RE: CITY OF MERCER ISLAND PERMIT APPLICATION
NUMBER 1410-199, HILLSIDE GRADING AT 7703 WEST MERCER WAY,
MERCER ISLAND, WASHINGTON

SHANNON & WILSON, INC.

RESPONSES TO NOVEMBER 14, 2014 CITY OF MERCER ISLAND LETTER

SITE IMPROVEMENTS PLAN
(After Construction)

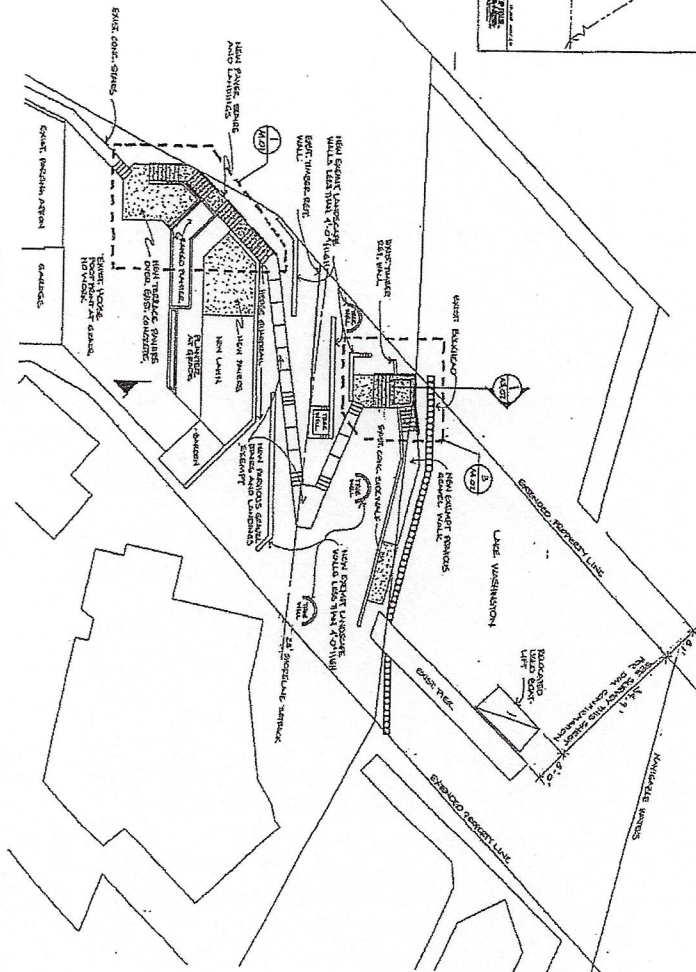
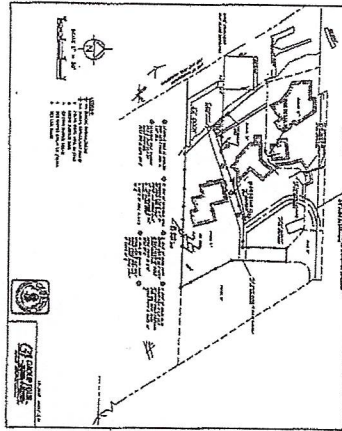
The retaining walls constructed at the site include SMU walls with and without mechanically stabilized earth (MSE). No new rockeries were constructed. The new construction consists of:

- The four SMU walls without MSE are less than 3.5 feet high. In our opinion, this wall height should be locally stable.
- The SMU wall with MSE reinforcement is up to 5 feet high. We understand a geotextile reinforcement layer was placed between every other SMU course, and extended 8 feet back from the wall face. In our opinion, the reinforcement was conservatively designed, so the wall should be locally stable.

- The SMU walls with and without reinforcement have drainage that consists of a 4-inch-diameter perforated pipe surrounded by clean gravel. The perforated pipes connect to tightlines that convey water away from the slope.

- Imported fill was limited to drainage aggregate for the SMU walls, and pervious trail surfacing aggregate. We understand pervious surfacing for trails is a code requirement. The total volume of imported aggregate was about 15 cubic yards. You reported no soil was exported from the site. In essence, the cuts and fills at the site were balanced, so no new loads were added to the slope.
